<b>Title - Sujet</b> CSIC Spare Parts Procurement Ops #2	
<b>Solicitation No. - N° de l'invitation</b> W8482-178639/A	<b>Amendment No. - N° modif.</b> 006
<b>Client Reference No. - N° de référence du client</b> W8482-178639	<b>Date</b> 2017-03-28
<b>GETS Reference No. - N° de référence de SEAG</b> PW-\$\$FX-010-26161	
<b>File No. - N° de dossier</b> 010fx.W8482-178639	<b>CCC No./N° CCC - FMS No./N° VME</b>
<b>Solicitation Closes - L'invitation prend fin</b> <b>at - à 02:00 PM</b> <b>on - le 2017-03-31</b>	
<b>Time Zone</b> Fuseau horaire Eastern Daylight Saving Time EDT	
<b>F.O.B. - F.A.B.</b> Specified Herein - Précisé dans les présentes	
<b>Plant-Usine:</b> <input type="checkbox"/> <b>Destination:</b> <input type="checkbox"/> <b>Other-Autre:</b> <input checked="" type="checkbox"/>	
<b>Address Enquiries to: - Adresser toutes questions à:</b> Saulnier, Jaime-Lynn	<b>Buyer Id - Id de l'acheteur</b> 010fx

Amendment 006

This amendment is raised to make the following changes to Annex A, and to add the following Questions and Answers to Appendix 1:

183) GAGE,PRESSURE,DIAL INDICATING, P/N P1554

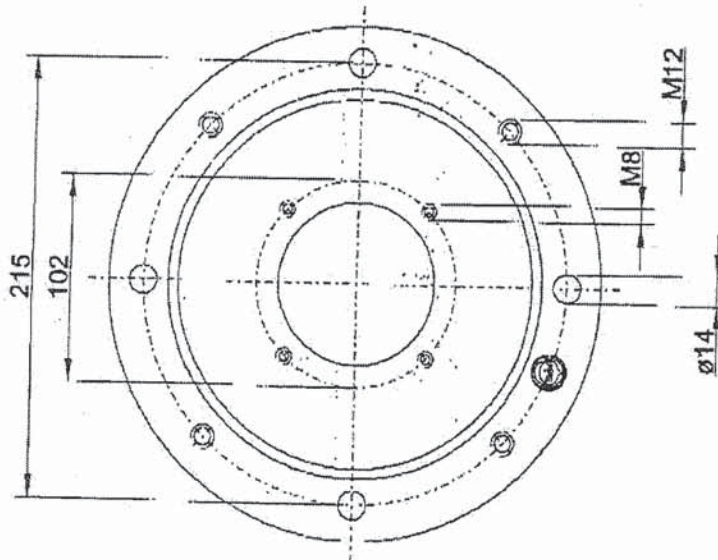
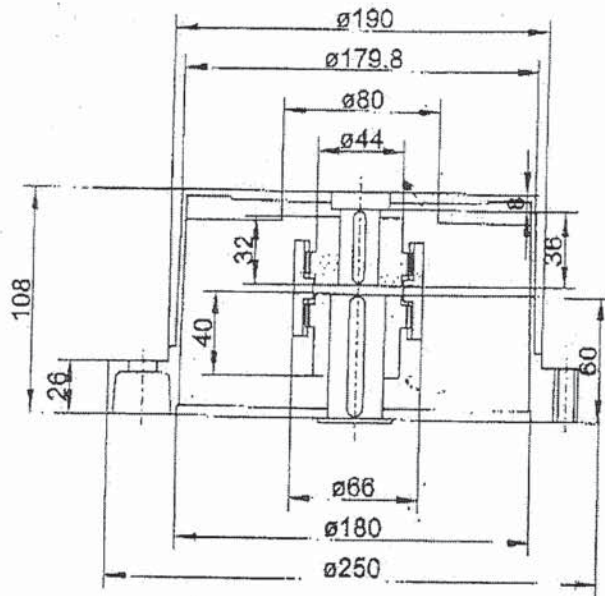
Can you please confirm the pressure range for the following line items:

184) GAGE,PRESSURE,DIAL INDICATING, P/N P1453

*For line item 183, the pressure range is 0 to 600mbar, and for line item 184, the pressure range is 0-10Bar.*
